#17468: Service Update - Insufficient Tape/Abrasion Protection on ABS Wiring - (Apr 11, 2018)

Models: 2018 Chevrolet Camaro

Reference Number: N172115540	Release Date: April 2018
Revision: 00

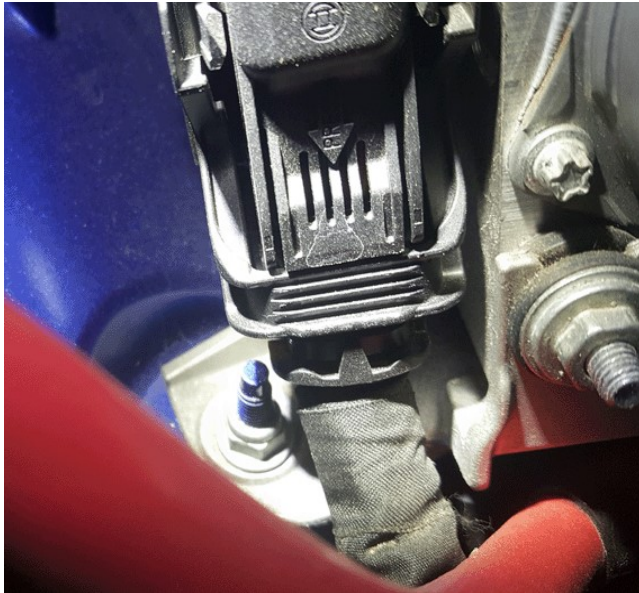
Condition	Certain 2018 model year Chevrolet Camaro vehicles may have been built with insufficient tape/abrasion protection on the Antilock Brake System (ABS) wiring near the body stud. This condition could rub through the ABS wires.
Correction	Install sleeve to wiring harness and secure with stud mounted clip.

1. Locate the wiring harness leading to the EBCM underneath the Windshield Washer Solvent Container Filler Tube.

2. Install the conduit and the clip to the harness as shown.
